**Inspection Photos**  
**Operator: Logos Operating**  
**API: 067-09136**  
**Date: 3/21/2022**

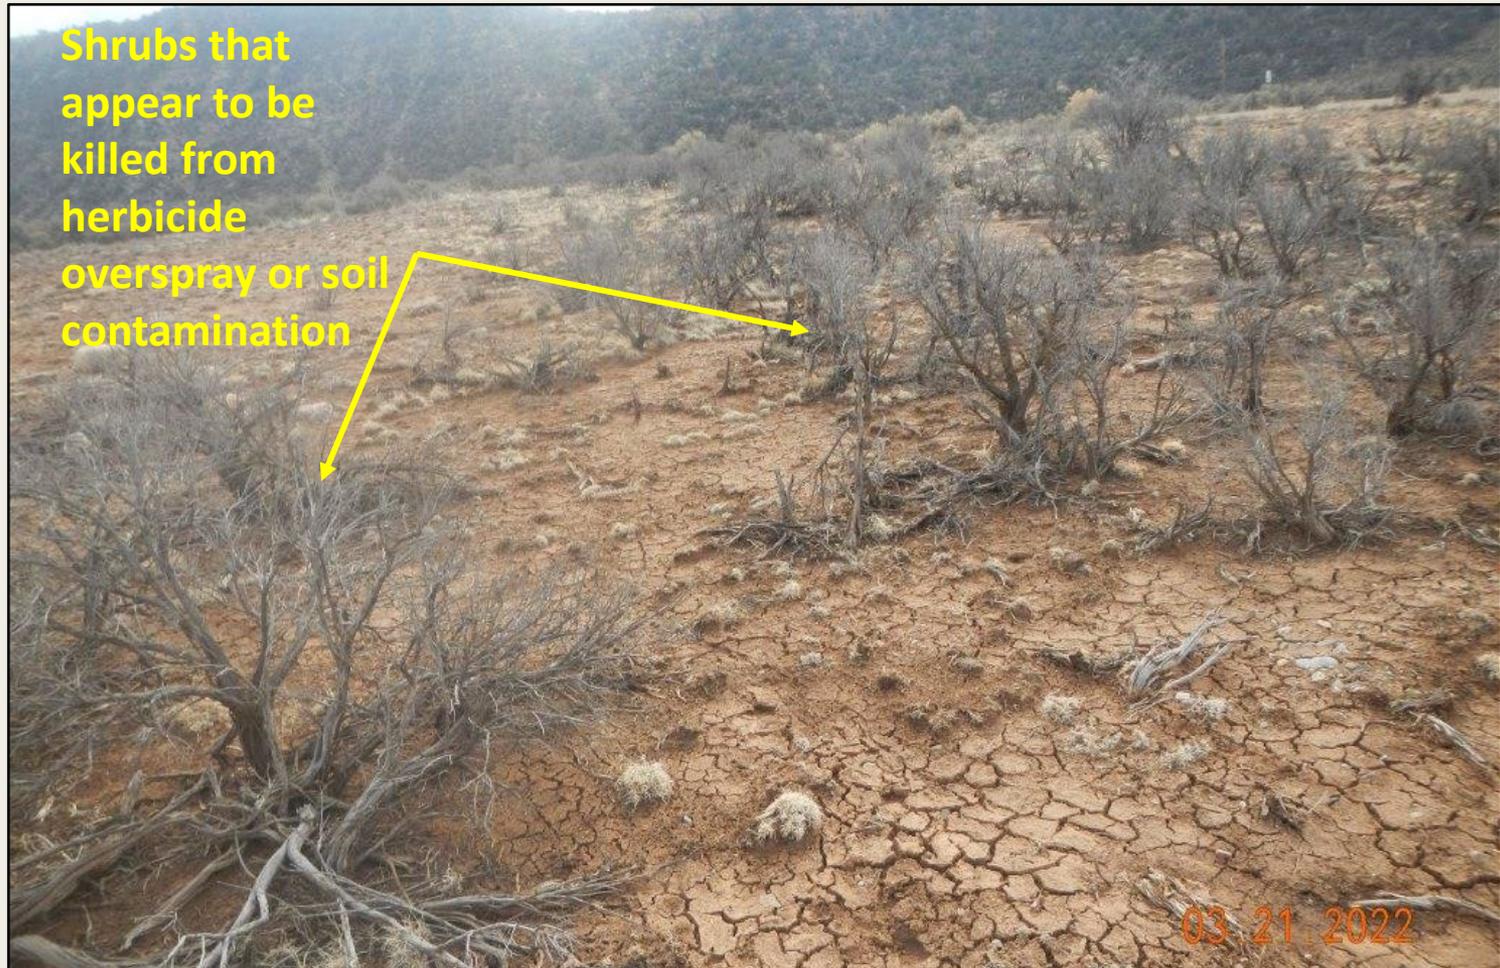
Photo 2. View of area where it appears that herbicide overspray has killed vegetation. Corrective action to revegetate areas where vegetation is killed from previous reclamation inspection is not addressed.

Photo 3. View of shrubs in the southeastern project area that appear to have been killed by herbicide overspray or soil contamination.

Photo 4. Another view of area in the southern project area (between access road and well pad, where vegetation is killed. Revegetation has not been conducted here. Topsoil scouring, pedestalling, and rilling observed.

Photo 5. View of the southern project area from the southeastern corner facing westward. Grasses in the foreground largely appear dead. Spot seeding is needed in areas with sparse and bare vegetation and where there is vegetation die-off.

Photo 6. View of open cellar around the wellhead needing cover for wildlife protection.
